ES Service Information

SI0155

Equipment Affected: YK Chillers

Microboard 031-02430-001

FIG. 1 - MEDIUM VOLTAGE DRIVE SERIAL COMMUNICATION (MODBUS PROTOCOL)

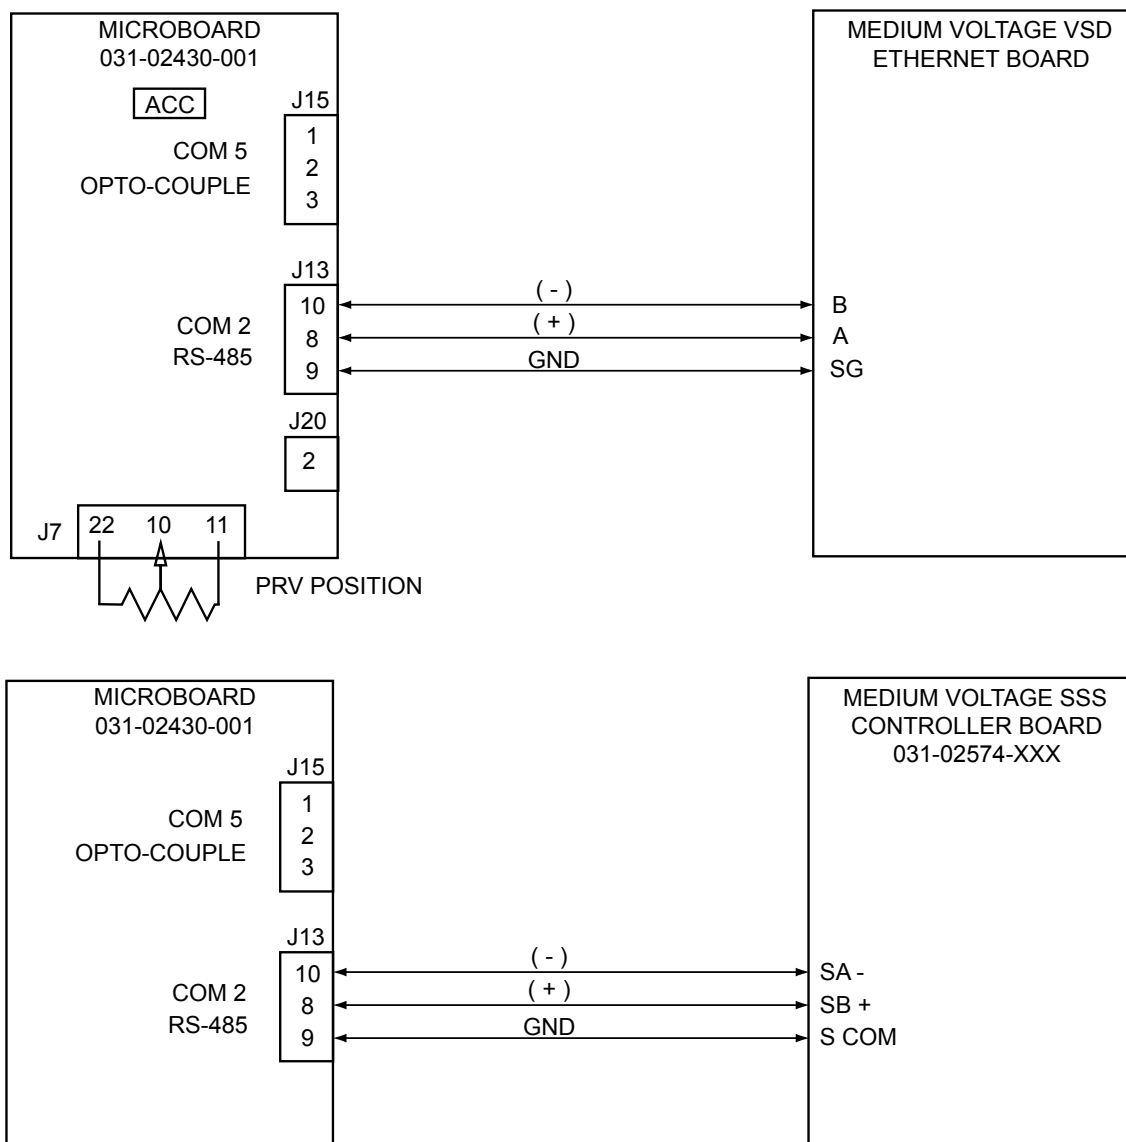
The 031-02430-001 microboard communicates with the Medium Voltage Solid State Starter (MV SSS) and Medium Voltage Variable Speed Drive (MV VSD) using the COM2 (J13) RS-485 port with Modbus protocol (ref FIG. 1). On the SETUP Screen, select either “MV SSS” or “MV VSD”, as appropriate, for the Motor Drive Type

FIG. 2 - VARIABLE SPEED DRIVE SERIAL COMMUNICATION (YORK PROTOCOL)

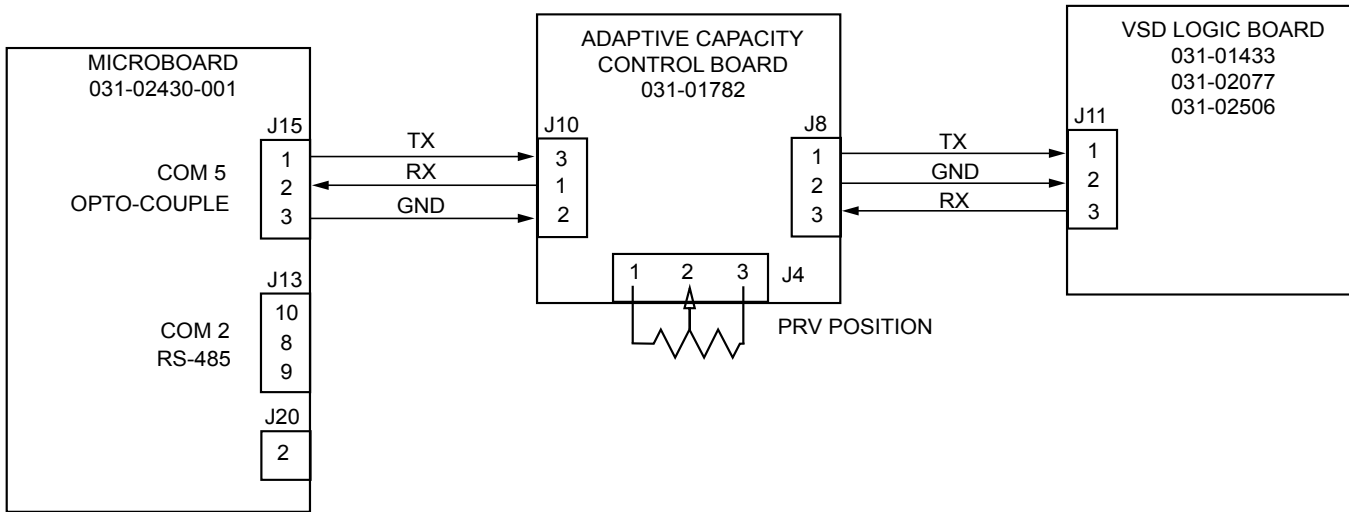
On new production chillers prior to June 2006, Microboard 031-01730-000 or 031-02430-000 COM5 serial port (J15) communicates with the Adaptive Capacity Control Board using YORK protocol. The COM5 serial port is retained on the 031-02430-001 microboard to allow it to be used as service replacement for these applications (ref

On new production chillers between June 2006 and March 2007, microboard 031-02430-001 COM5 serial port (J15) communicates with the Adaptive Capacity Control Board using YORK protocol (ref FIG. 2).

FIG. 3 - VARIABLE SPEED DRIVE SERIAL COMMUNICATION (MODBUS PROTOCOL)

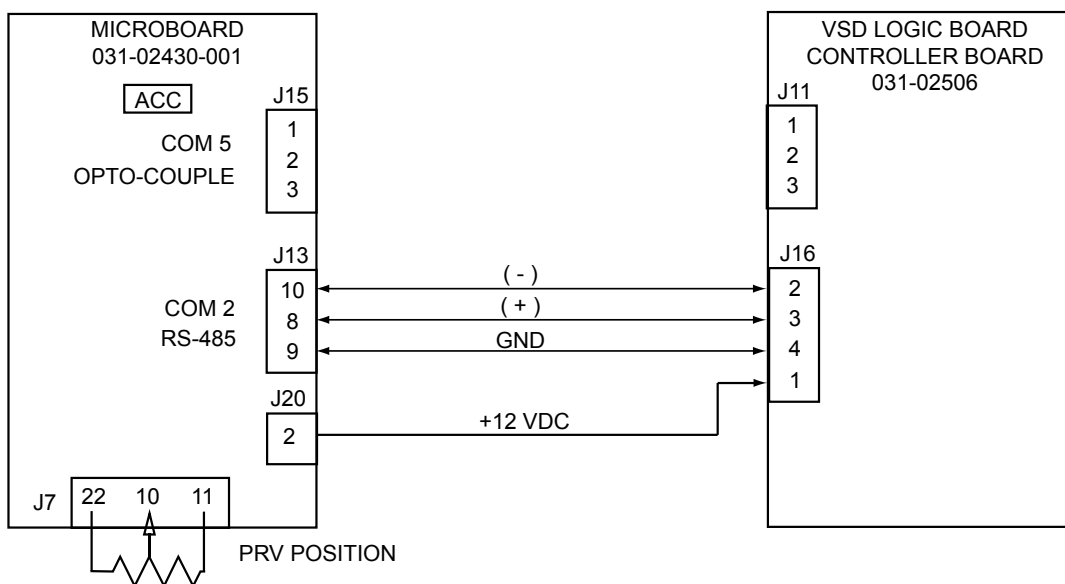
On new production chillers after March 2007, the 031-02430-001 microboard COM2 (J13) serial port communicates directly with VSD Logic Board 031-02506 using RS-485 Modbus protocol (ref FIG. 3). Software version C.OPT.01.16.xxx (or later) is required for COM2 Modbus operation. With the VSD Modbus protocol, the Adap-

With software version C.OPT.01.16.xxx (or later), when VSD-50Hz or VSD-60Hz is selected for the Motor Drive Type setpoint on the SETUP Screen, the Motor Communications Protocol Setpoint must be set to either “YORK” or “MODBUS” as appropriate. If “MODBUS” is selected, the “MOTOR NODE ID” setpoint must be set to “1” to match the VSD Logic Board Modbus address Switch SW3, which is also set to “1”.

FIG. 4 - STYLE "B" SOLID STATE STARTER SERIAL COMMUNICATION (YORK PROTOCOL)

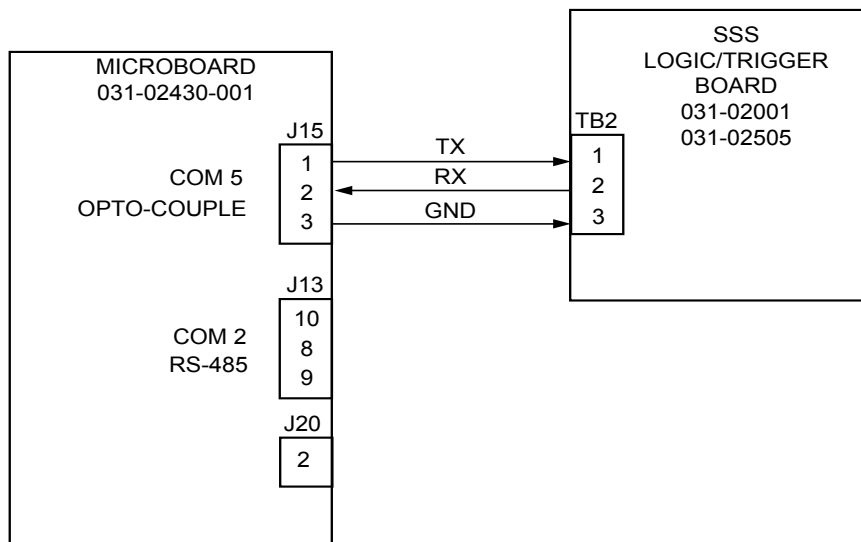
On new production chillers prior to June 2006, microboard 031-01730-000 or 031-02430-000 COM5 serial port (J15) communicates with the LCSSS Logic/Trigger Board 031-02001 using YORK protocol (ref FIG. 4). The COM5 serial port is retained on the 031-02430-001 microboard to allow it to be used as service replacement for these applications (ref FIG. 4).

On new production chillers after June 2006, Microboard 031-02430-001 COM5 Serial Port (J15) communicates with the LCSSS Logic/Trigger Board 031-02001 using YORK protocol (ref FIG. 4). Later in 2007, it will communicate with Logic/Trigger Board 031-02505 using the same interface/protocol.
